CITY OF AUSTIN
Board of Adjustment
Decision Sheet
F-2

CASE NUMBER: C15-2020-0083

BOA GENERAL REVIEW COVERSHEET RE-NOTIFICATION

Master Comment Report

The Salazar Residence
2810 Gonzales St.
Austin, Texas 78702
SITE PLAN

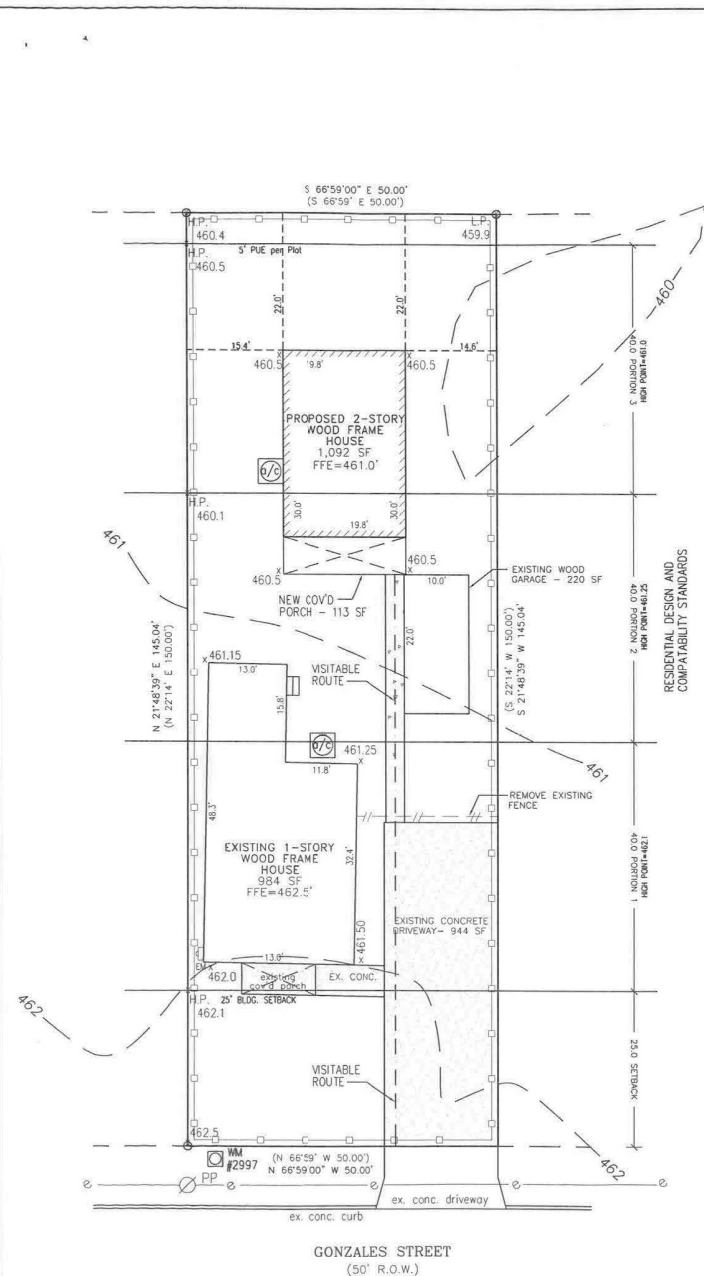
2. The existing storage shed above, is described on the site plan as a garage. As this structure is not permitted as a garage, please remove note.
3. SUBCHAPTER F: Part of the architectural plans are missing architect's signature. This lot is located in the Subchapter F overlay boundaries and is more than one story or is greater than 20 feet. The plan set must be signed and sealed by Texas Licensed Architect or Certified Building Design Profession. Please refer to documentation requirements on the application – Design Professionals.
